June 17, 2019

**Re: Response to DEP Request for Additional Information
Hydrogeological HDD Re-Evaluation Report – Interstate 81 Crossing 16"
Horizontal Directional Drill Location (S2-0220-16)
Permit No. E21-449
Middlesex Township, Cumberland County**

Figure 1. Permitted 16-inch HDD Plan and Profile with 20-Inch IR Data

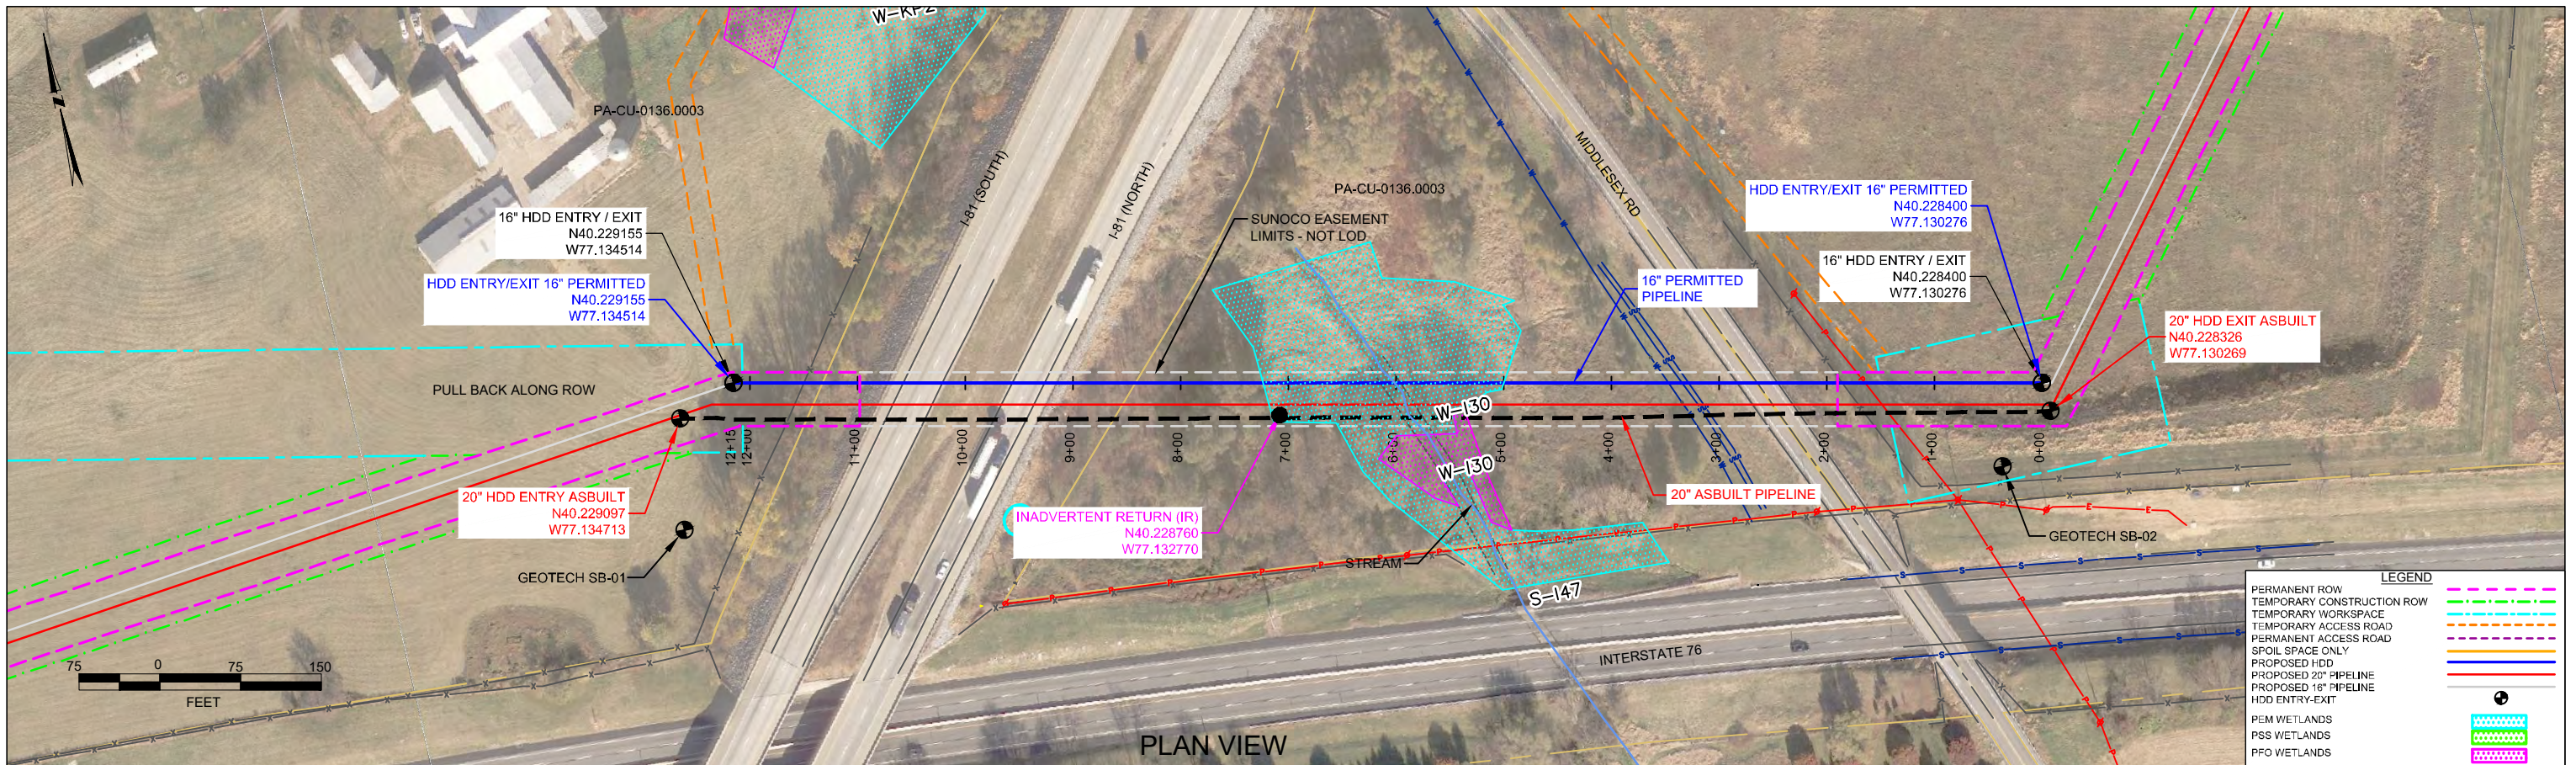
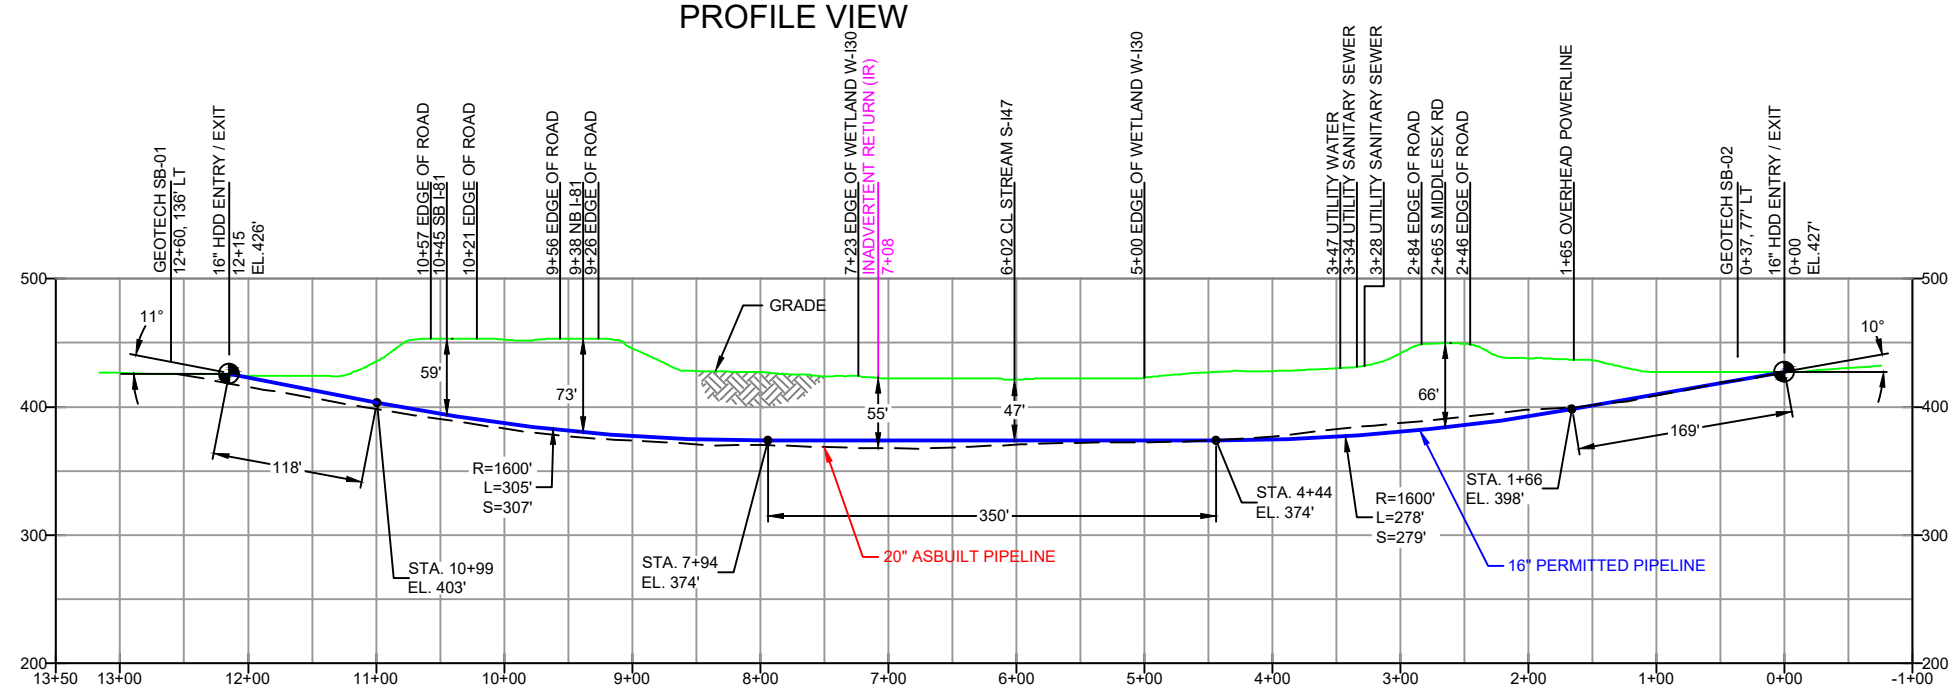
- 1. Examination of the drilling record for the 20-inch pipeline boring indicates a persistent and significant loss of circulation (LOC) and inadvertent return (IR) that began approximately 500 feet from the east of the bore. It continued for most of the duration of drilling. The s-wave seismic profile (figure 4 of 7, Geophysical Report) indicates that a deeper pathway of 20 additional feet would place the bore in a zone of higher velocity bedrock underneath the persistent IR location and interval to the east of that IR location. Please discuss the possibility of designing the profile even deeper to pass beneath the low velocity feature on figure 4, Geophysical Report.**
